MODEL AFFECTED: 205A & 205A-1

SUBJECT: UPPER CREW DOOR HINGE STRUCTURE,
REINFORCEMENT OF.

HELICOPTERS AFFECTED: Model 205A and 205A-1 helicopters serial
number 30001 through 30332.

Figure 1 (Sheet 1 of 2)

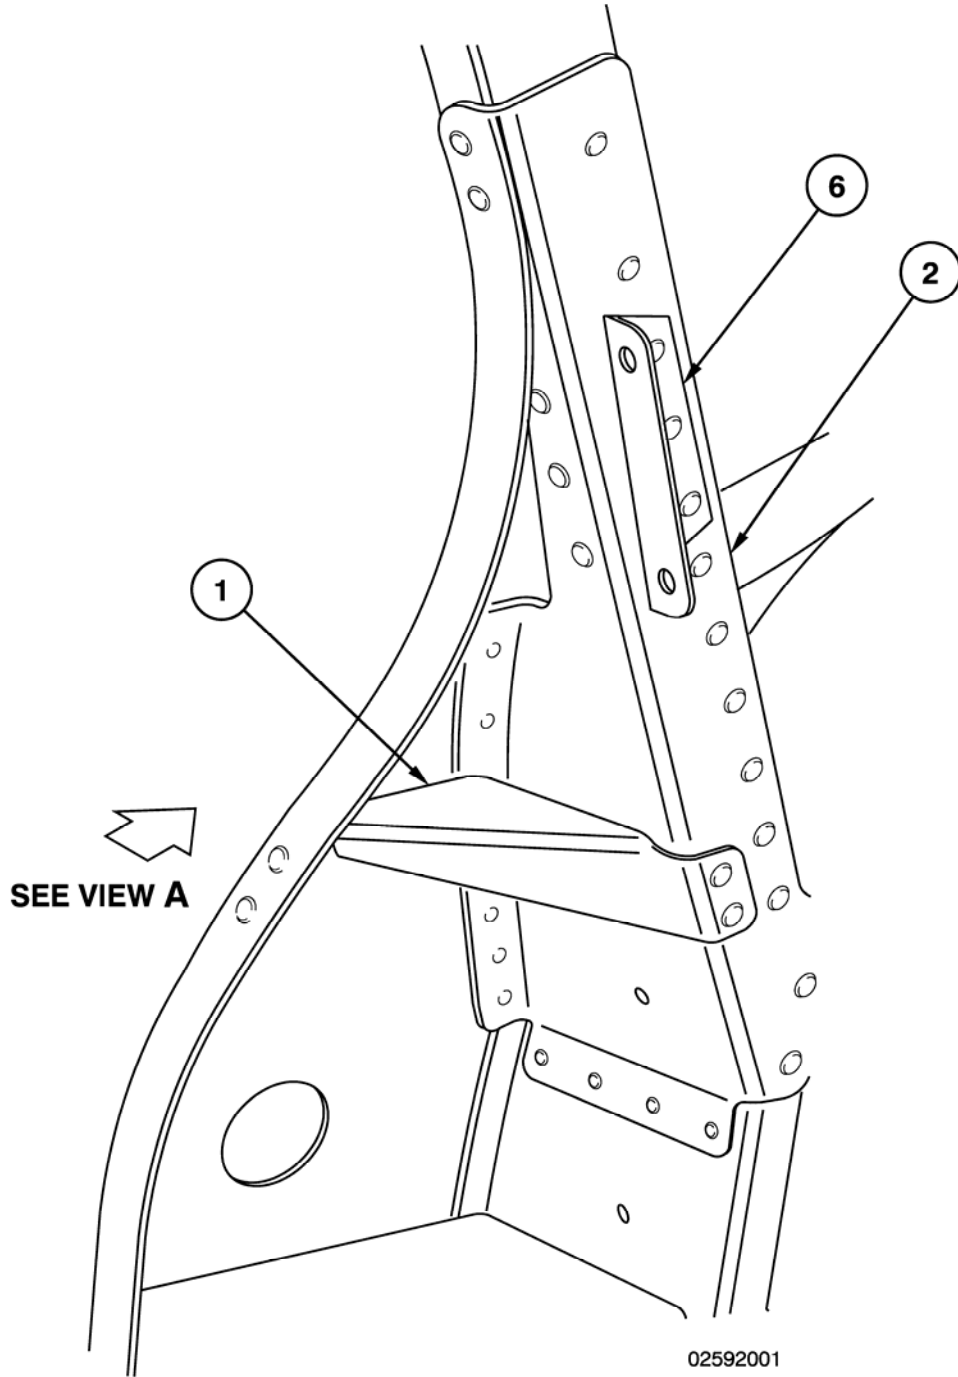
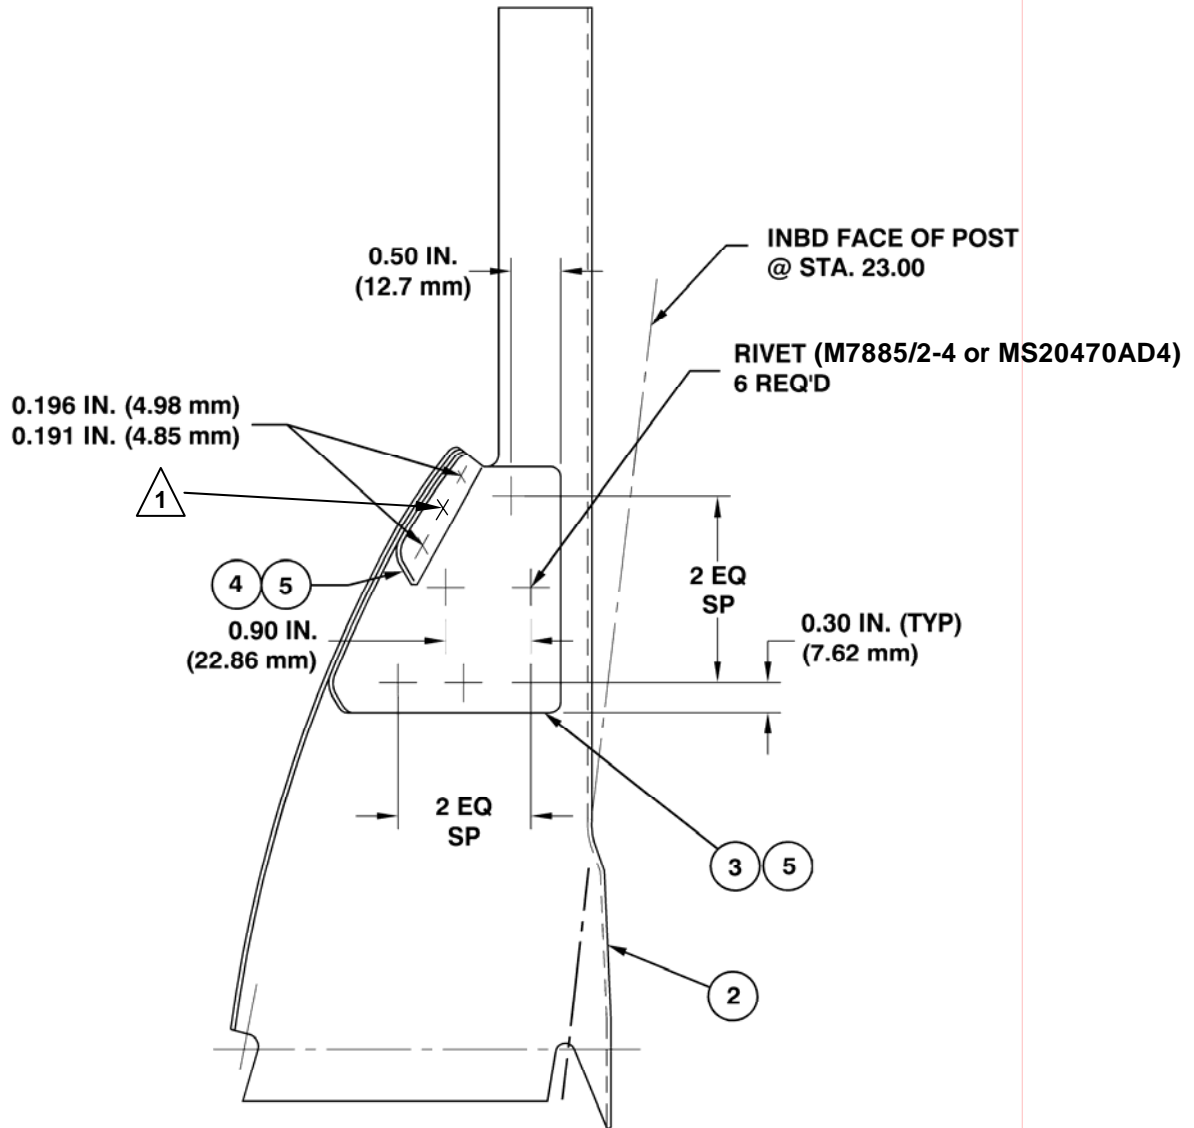
Bell Helicopter has received some reports of cracking occurring at supports P/N 204-030-662-013 & -014 caused by the crew doors repeatedly hitting their open stop, especially under windy conditions. This bulletin provides the instructions for a simple reinforcement to the surrounding area.

5. On left side, remove instrument panel support fitting (6).
6. Remove support (1) and support (2) as a unit. Remove support (1) from support (2).
7. Fit doubler (3) and radius block (4); refer to View A. See note 1 in Figure 1. Verify for possible interference with support (1) and trim doubler as required. Trim radius block to follow edge of doubler (3) and support (2). Secure with Cleco fasteners.
8. Rework existing support (1) as per Figure 2 or fit new support.
9. Remove supports (1 and 2), doubler (3), radius block (4) and deburr.
10. Apply adhesive (C-317) to doubler (3) and radius block (4) and install using M7885/2-4 rivets (or MS20470AD4 rivets). Remove excess adhesive.
11. Install support (1) on support (2)

12. Install supports (1 and 2) and fitting (6).
13. Re-install upper door hinge using existing hardware except replace two existing screws with two MS27039-1-13 screws at the aft holes.
14. Rework existing ejection assy as per Figure 2 or replace with new ejection assy. Re-install door-jettisoning mechanism.
15. Repeat steps 5 to 14 for right side.
16. Apply a bead of sealant (C-308) around upper door hinges, doublers (3), radius blocks (4) and refinish as required.
17. Re-install crew doors.
18. Prepare aircraft for flight.
19. Make an entry in helicopter historical records indicating compliance with this technical bulletin.
